TRANS/WP.29/GRE/2002/42  
18 July 2002

World Forum for Harmonization of Vehicle Regulations (WP.29)

PROPOSAL FOR DRAFT AMENDMENTS TO REGULATION No. 112

(Headlamps emitting an asymmetrical passing beam)

Figure 1:

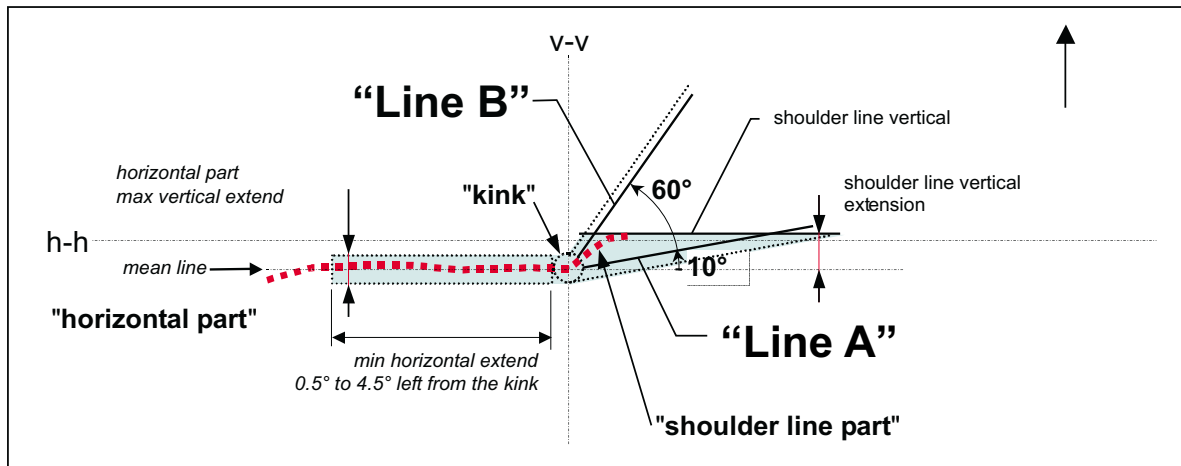
For visual adjustment of the passing beam the cut-off line shall provide a horizontal line for vertical adjustment of the headlamp between  $0.5^\circ$  and  $4.5^\circ$  distant from the v-v-line (see Figure1), which does not exceed a vertical extend of  $\Delta\beta = 0.2$  degree up or down.

Figure 2:

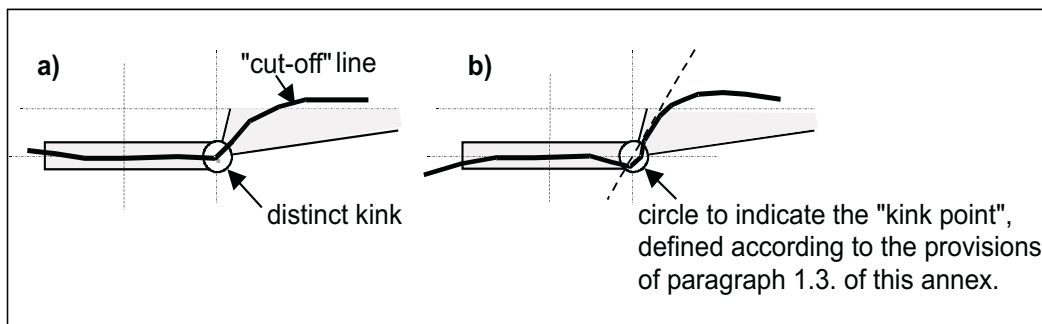
"elbow" is situated at the v-v-line. If the "elbow" forms no sharp enough edge, that point shall be taken, where the horizontal line through the straight part and the steepest tangential line onto the shoulder part of the cut-off line are crossing (for examples see Figure 2). The "shoulder line part"

- (a) does not extend the tangential line "B" going from the "kink" upwards to the right and being inclined versus h-h by  $60^\circ$ ;
- (b) does not extend the tangential line "A" going from the "kink" upwards to the right and being inclined versus h-h by  $10^\circ$ .
- (c) has a vertical extension of at least  $\Delta\beta = 0.57^\circ$  over a distance of  $2^\circ$  to the left (right hand traffic) and  $2^\circ$  to the right (left hand traffic).

Figure 3:

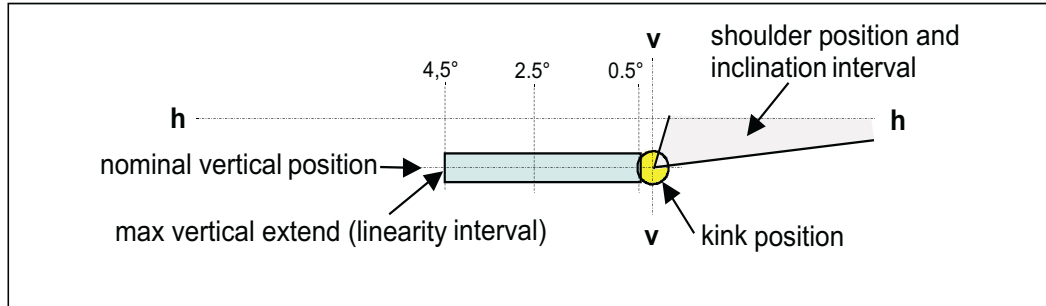
The part of the cut-off line which serves vertical adjustment shall be horizontal between 0.5° and 4.5° distant from the v-v-line. This requirement is deemed to be met when the vertical position of the inflection points (where  $d^2(\log E) / d\beta^2 = 0$ ) at 1.5°, 2.5° and 3.5° horizontal distance from the v-v-line are located within a band width of + 0.2° from the nominal vertical position of the cut-off line at 2.5° sideward of the v-v-line, see Figure 3.
